**PETITION NO:** Z-97

# Z-97

**ZONING COMMENTS:**

The applicant is requesting rezoning of the subject property from the current R-20 single-family residential district to the R-15 single-family residential district in order to develop a six (6) lot subdivision on 3.1 acres.

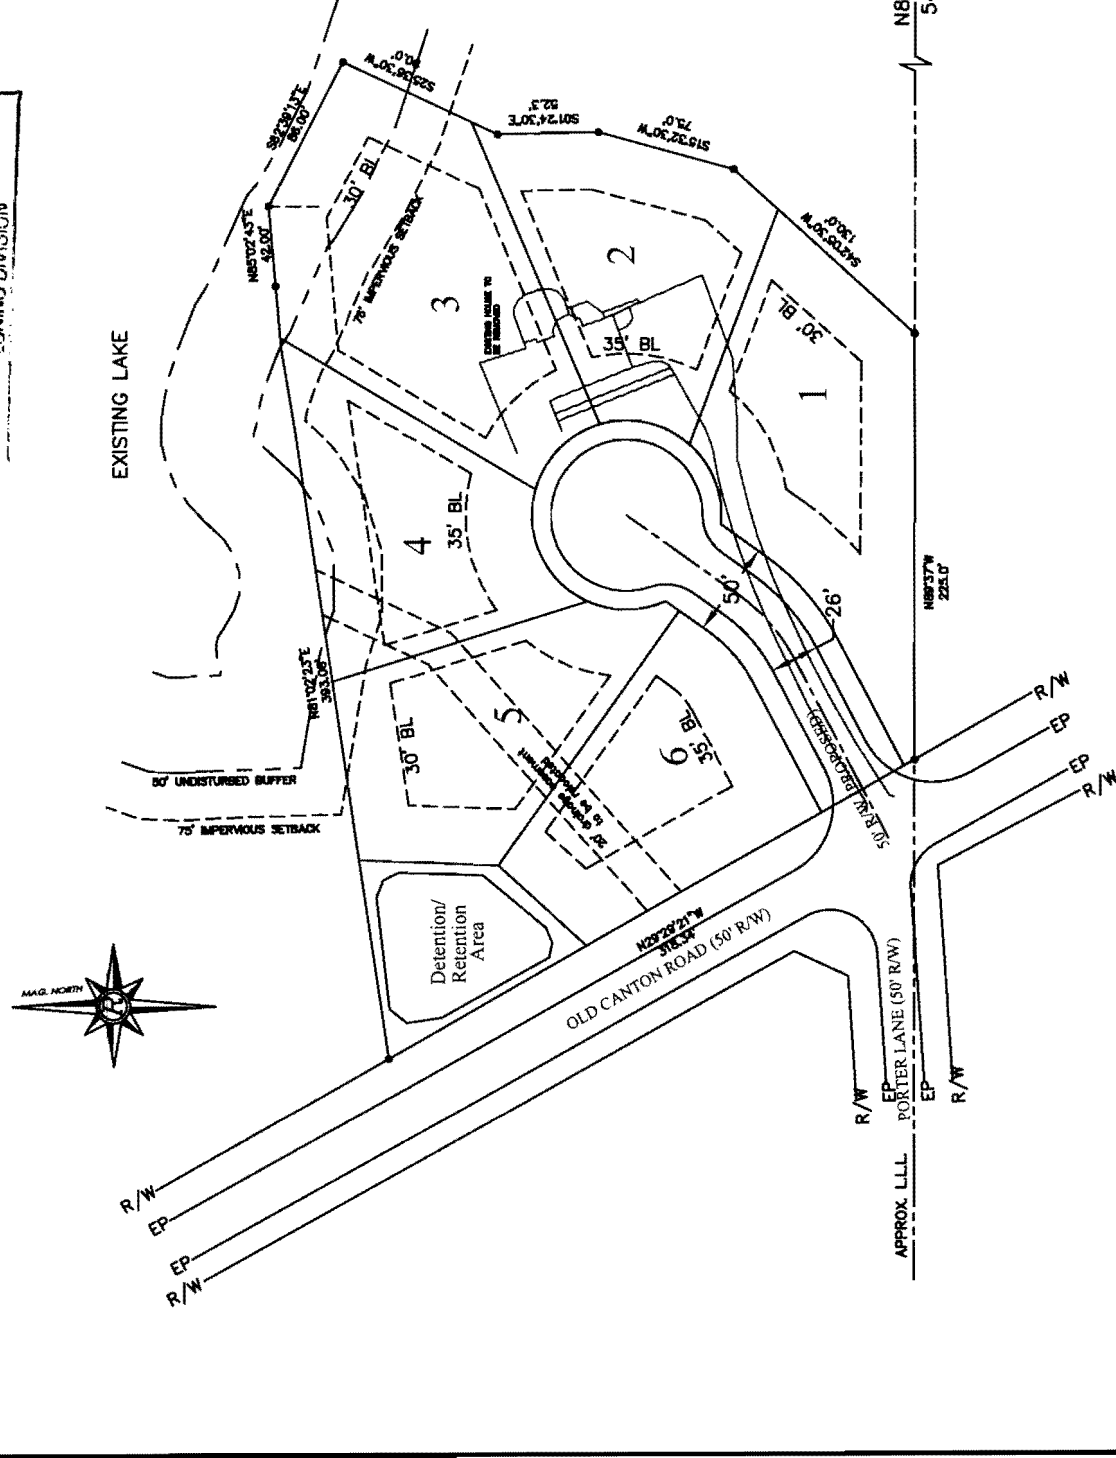
- Provide comprehensive hydrology/stormwater controls to include development of out parcels.
- Submit all proposed site improvements to Plan Review.
- Any **spring activity** uncovered must be addressed by a qualified geotechnical engineer (PE).
- Structural fill \_\_\_\_\_ must be placed under the direction of a qualified registered Georgia geotechnical engineer (PE).
- Existing facility.
- Project must comply with the Water Quality requirements of the CWA-NPDES-NPS Permit and County Water Quality Ordinance.
- Water Quality/Quantity contributions of the existing lake/pond on site must be continued as baseline conditions into proposed project.
- Calculate and provide % impervious of project site.
- Revisit design; reduce pavement area to reduce runoff and pollution.

- No Stormwater controls shown \_\_\_\_\_
- Copy of survey is not current – Additional comments may be forthcoming when current site conditions are exposed.
- No site improvements showing on exhibit.

1. This site is located on the east side of Old Canton Road just across from its intersection with Potter Lane. The entire site drains to the north into Saddle Ridge Lake, a private lake owned by the Saddle Ridge Lake Club, Inc.
2. A pre- and post-development sediment survey will be required for the Saddle Ridge Lake as well as a hydrologic routing to verify no adverse impact to the lake.
3. There is an existing 30-inch RCP culvert traversing the site that conveys runoff from the Orchard Grove Subdivision to the west as well as the Old Canton Road R/W. This pipe will need to be relocated to accommodate the proposed site layout.

Recommend applicant consider entering into a development agreement pursuant of O.C.G.A. 36-71-13 for dedication of the following system improvements to mitigate traffic concerns: a) donation of right-of-way on the east side of Old Canton Road, a minimum of 50' from the roadway centerline.

Recommend replacing disturbed curb, gutter, and sidewalk along the Old Canton Road frontage.

Recommend curb and gutter along both sides and sidewalk along one side of proposed development roadway.

- Site plan received by the Zoning Division on September 14, 2015 with the District Commissioner approving minor modifications;
- Fire Department comments and recommendations;
- Water and Sewer Division comments and recommendations;
- Stormwater Management Division comments and recommendations;
- Department of Transportation comments and recommendations; and
- Owner/developer to enter into a Development Agreement pursuant to O.C.G.A. §36-71-13 for dedication of system improvements to mitigate traffic concerns.
